SERVICE BULLETIN

DATE:	October 24, 1997	SERVICE BULLETIN #	SB-1535	# OF PAGES: 2
SUBJECT:	TELESIS / FXC MODEL 12000 RESERVE ACTIVATION CHECK			
STATUS:	RECOMMENDED

1. Telesis with FXC Model 12000 Reserve Installation

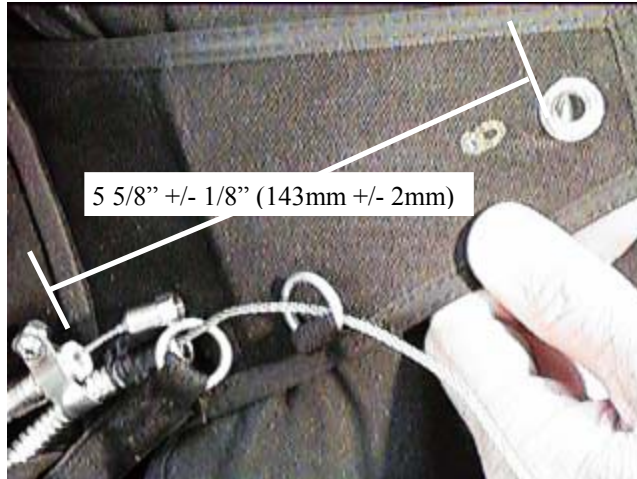
Rigs have been found to have AAD activation without extraction of the ripcord pin. Investigation found that affected rigs were packed with canopies at the upper limit of container volume such that the top reserve container flap (#1) is curved over the top of the tightly stuffed deployment bag. Activation of the AAD resulted in movement of the reserve ripcord housing and FXC power cable toward the pin. The movement effectively shortened the travel of the power cable and the movement of the pin. This bulletin recommends test activation of all FXC equipped Telesis reserves and checking of the distance from the end of the power cable to the edge of the grommet in the #1 top flap.

The simple modification requires the FXC power cable to be moved away from the closing loop by loosening the clamp, sliding the clamp and housing back, and retightening the clamp. Measure the straight line distance from the plastic insert end of the power cable to the nearest edge of the grommet in the #1 top flap. The distance should be 5 5/8" +/- 1/8" (143 mm +/- 2 mm). Tighten clamp securely. Ensure that clamp and power cable cannot slip by pulling hard in both directions.
